TRAILS AT OVERLAND RANCH - SITE PLAN 1

SITE PLAN

COVER SHEET

4 FAUX CORRAL FENCE

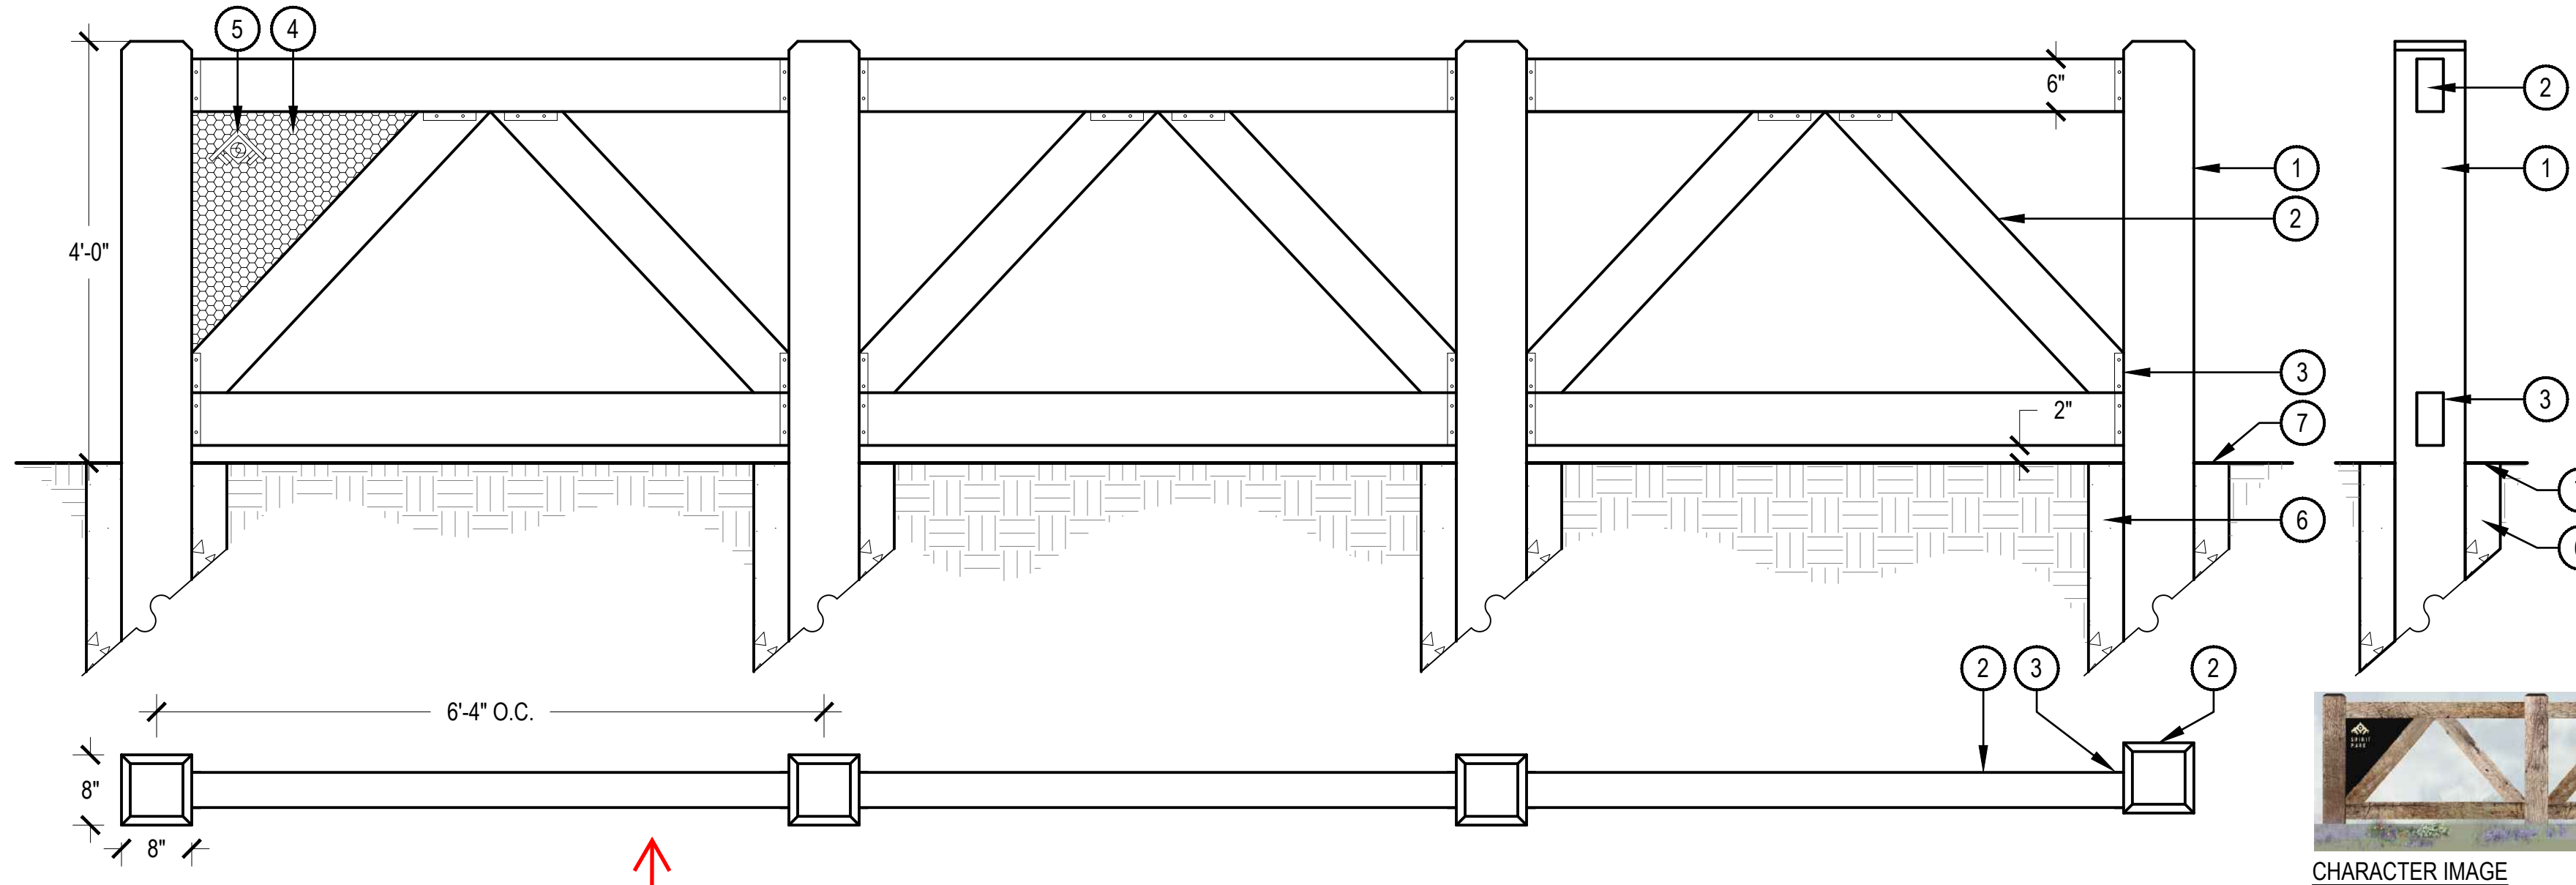
Where is this fence used on the Sheet 52?
